Ritron Model(s):	LM-700DMR and RIB-700DMR
Current Firmware Revision:	47.24
Revision Update:	Jul 17, 2025

LM-700DMR and RIB-700DMR Firmware Revision and Update History

R614 vs. V22/V21

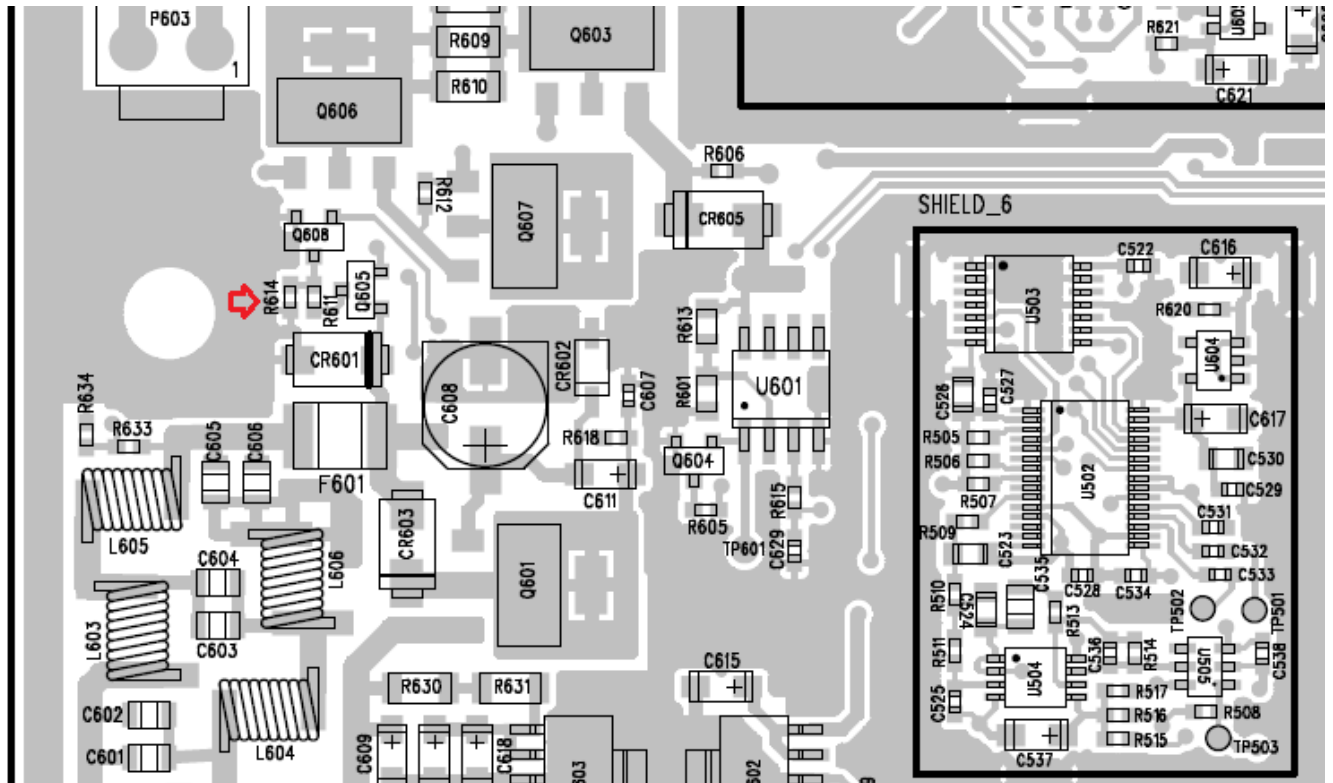
- 1) Added a feature that the unit can auto shutdown when 12V external power is lost and the battery is below 9.5V for at least 5 seconds. Before auto shutdown, the unit will beep 3 times. It is to prevent internal backup battery from over draining. To enable this feature, R614 (0 ohm) has to be removed. R614 was populated on the early units. With V22, if R614 is not removed, the unit will still work like V21, the battery dead auto shutdown just does not work. For the old version firmware, V21 and earlier, if R614 is depopulated, the battery backup function will stop working. i.e. depopulated R614 needs V22 or newer f/w to make the battery backup function work.

R614	Depopulated (new built)	Populated (old built)
F/W V22 and newer	Dead battery auto shutdown (lower than 9.5V) enabled	Dead battery auto shutdown (lower than 9.5V) is disabled, Same as V21 or older
F/W V21 and older	Battery backup function will stop working	Dead battery auto shutdown (lower than 9.5V) is disabled

Updated: Added above R614 part locator on Jul 8, 2025.
